May 26th, 2022

Monte Hilleman, SVP Sustainable Development
St. Paul Port Authority (SPPA)
400 Wabasha St N, Suite 240
St. Paul, MN 55102

The Heights (formerly Hillcrest) Redevelopment
Urban Design Work Group – Letter of Consensus Recommendations

Figure 1. Privately-owned public space (POPS) in The Heights

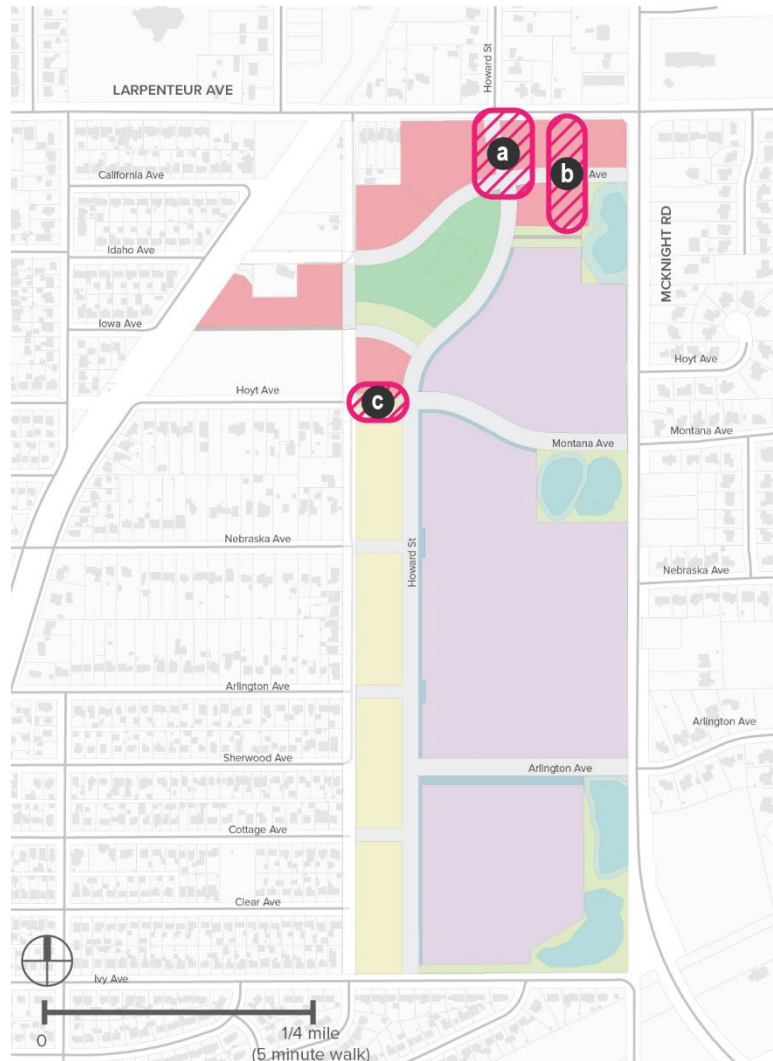
8. **Programming** – In addition to providing varied amenities for residents, employees, and visitors, privately-owned public space (POPS) should be provided in strategic locations throughout The Heights (see Figure 1). These POPS should be owned, operated, and maintained by the developer/owner, provide 24-hour public access, and include a diverse range of programming. Potential locations have been identified as:
- a. Curved zones right along Howard between Larpenteur and Idaho.
 - b. The north-south pedestrian alley on the northeastern-most block, connecting Larpenteur to the northernmost wetland.
 - c. Hoyt Avenue pedestrian greenway connection.

- A festival street/pedestrian-oriented alley should run north-south through the northeastern-most block of The Heights, continue across Idaho, and connect to the northernmost wetland (see Zone B in Figure 1).

Figure 2. Locations for 3rd story step-backs: pink – strongly preferred; orange – preferred

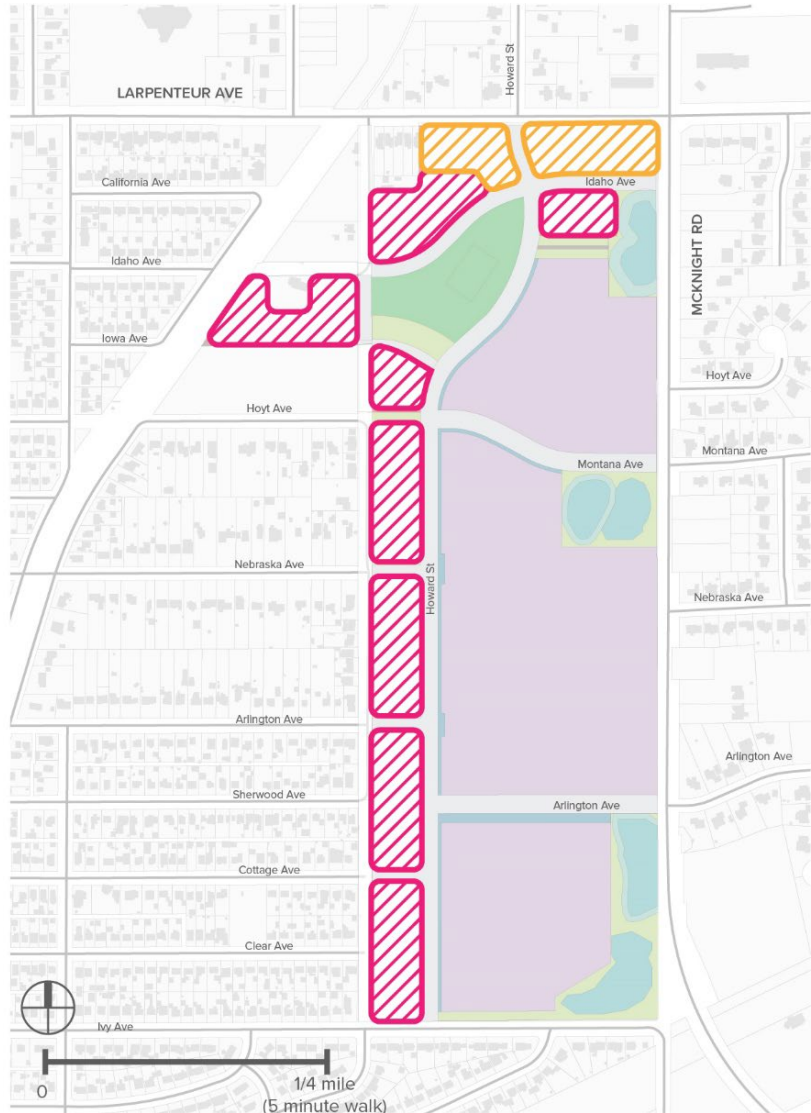
- Step-backs should be utilized in strategic locations (see Figure 2) to reduce the perceived scale of new development relative to the existing neighborhood and the scale of pedestrians.
 - Strongly preferred third-story step-back along interior ROW outside of neighborhood node, and Winthrop and Ivy.
 - Preferred third-story step back along interior roads within the neighborhood node.

Figure 3: Allowed frequency of identical building types in a row

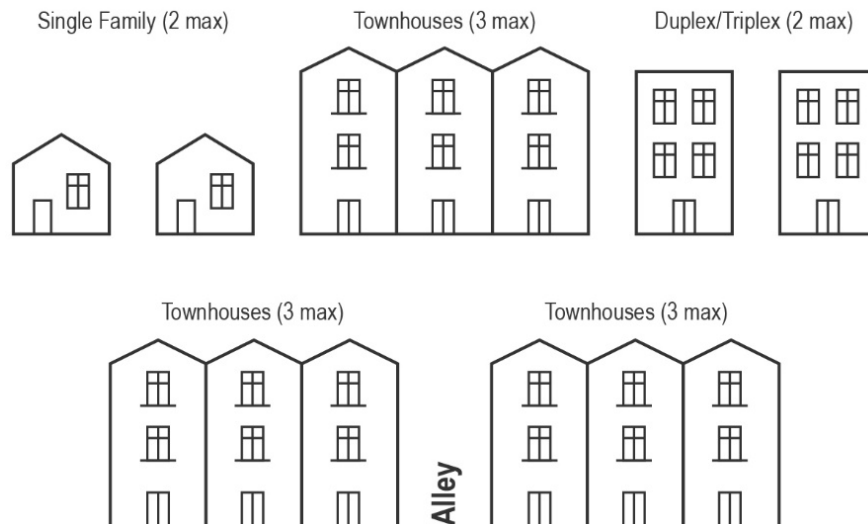
- Each block must provide at least four types of buildings/dwelling unit types (i.e. can't all be townhomes; need to include townhomes, duplexes, triplexes, and multiplexes)
- There should be no more than two similar/identical building types in a row. In the case of townhomes, there may be three similar building types in a row. If an alley separates them, there may be up to six similar types in a row (see Figure 3).

Figure 4. Building orientation: pink – facing E/W streets; orange – facing N/S streets

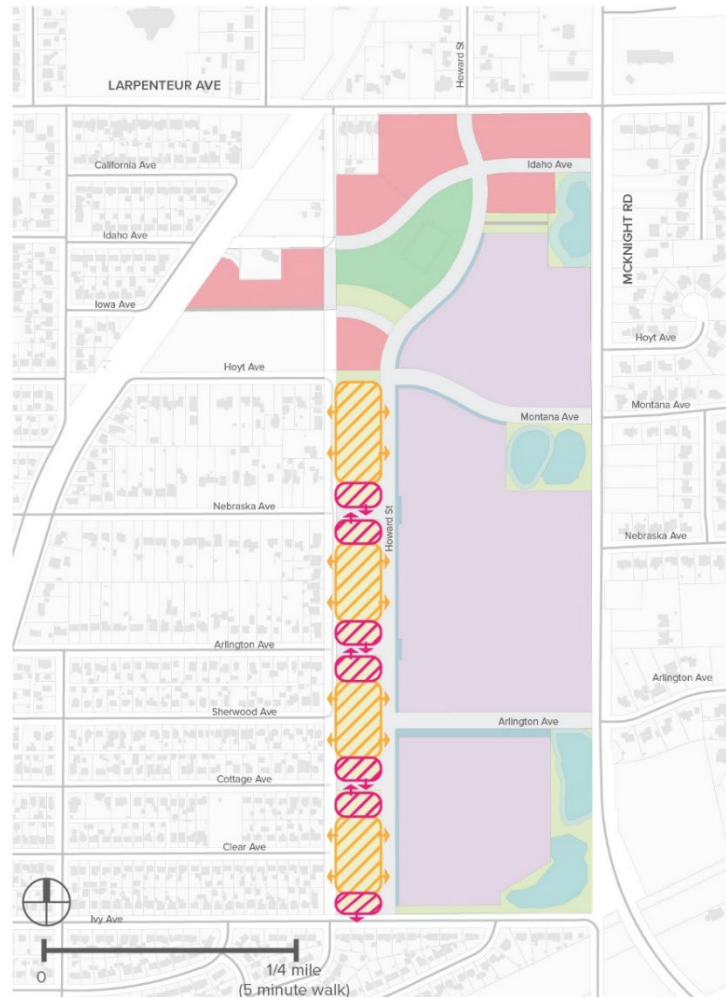
- The parcels adjacent to Ivy, Cottage, Arlington, and Nebraska should have their front yards oriented toward those east-west streets, so buildings on the short end of the blocks are oriented the same way as those in the existing neighborhood on the west side of Winthrop (see Figure 4).
 - The corner side yard setback for these parcels should be 24'.
- Parcels adjacent to only either Winthrop or Howard should have their front yards oriented toward those north-south streets, so buildings on the long sides of the blocks are facing Winthrop or Howard (see Figure 4).

Figure 5. Light Industrial building color palette (from hexadecimal color code)

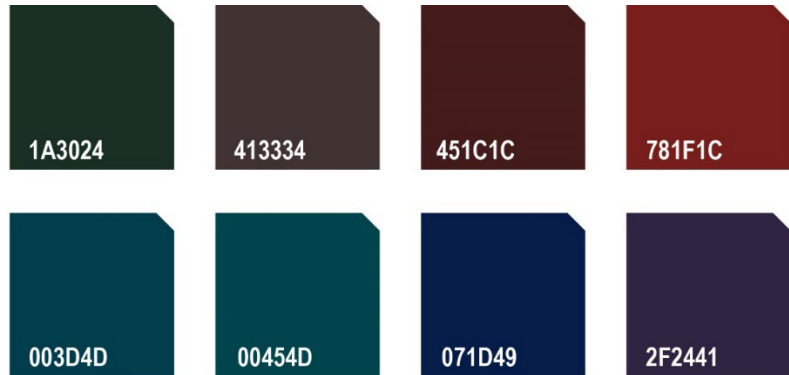
- The following requirements should be added to the Arts & Employment District guidelines:
 - Exterior building colors should be restricted to a cohesive “jewel-tone” color palette from a limited palette of specific, approved colors (see Figure 5).

- These colors should be rich and dark in tone and add subtle design interest to the neighborhood. By limiting the color palette, building owners may maintain a suitable background to showcase the mural art.
- No two adjacent properties, regardless of whether they are separated by a public right-of-way, may have the same exterior color.
- Building entries should have enhanced glazing levels (i.e. lots of windows).
- Building entries should conform to the standard tower/vestibule concept put forth by the Port Authority’s consultant team at Meeting 8 of this Work Group. We feel that plenty of visual interest and variety is being provided by the murals and vegetation around the building, and that consistency should be maintained in the design of the entries (see Figure 6).

Figure 7. Building orientation: pink – facing E/W streets; orange – facing N/S

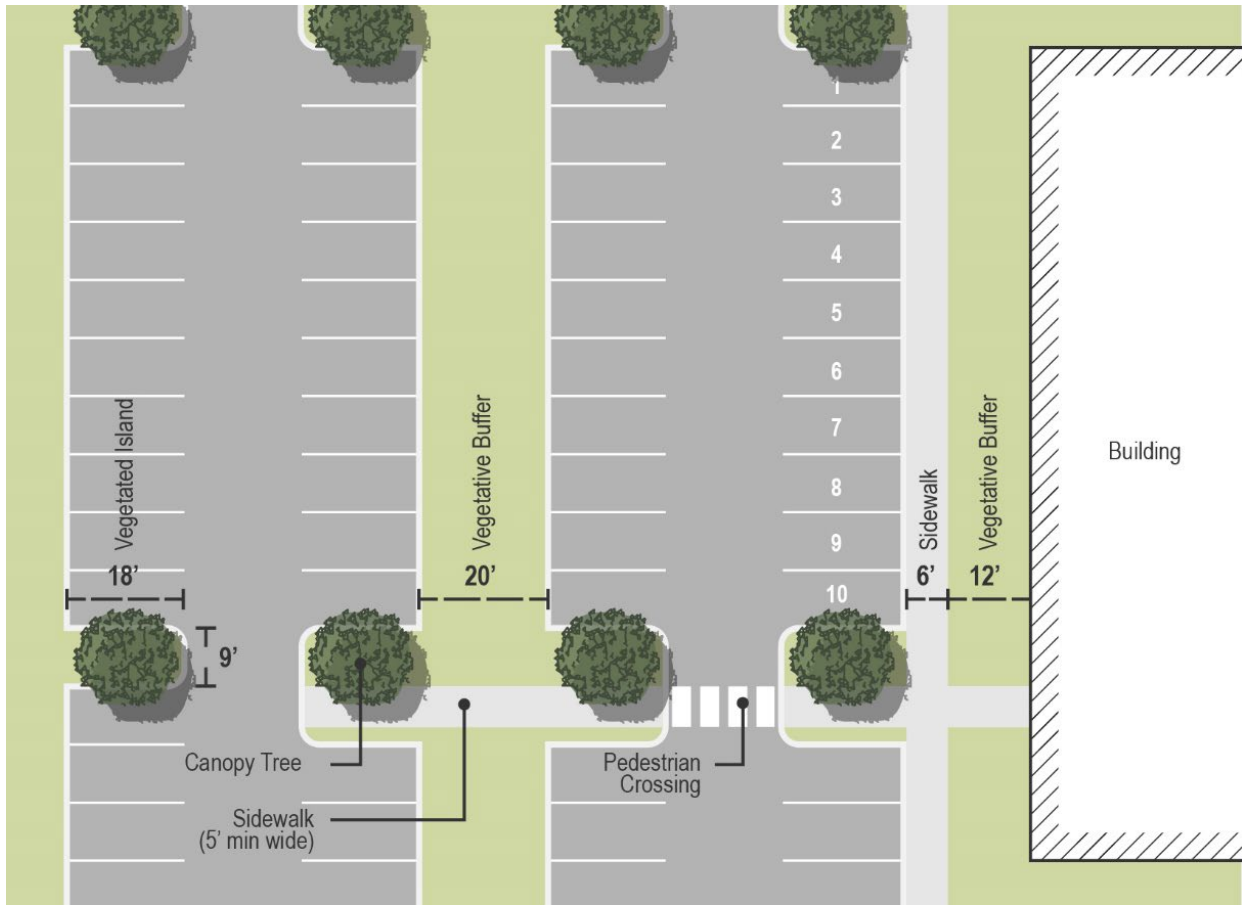
- In locations where four rows of parking run parallel to each other, the first parking/drive-aisle/parking zone should be separated from the second with a parallel, 20'-wide vegetative buffer. The vegetative buffer should be used for green infrastructure stormwater treatment as much as is practical (see Figure 7).

- For every ten parking spots, a 9 x 18' vegetated island should be included in the parking lot layout. This island should be planted with a canopy tree (see Figure 7).

- A minimum 6'-wide sidewalk should run parallel to the parking row nearest the building (see Figure 7).
- A minimum 12'-wide vegetative buffer should run parallel to the parking rows/sidewalk next to the building façade (see Figure 7).
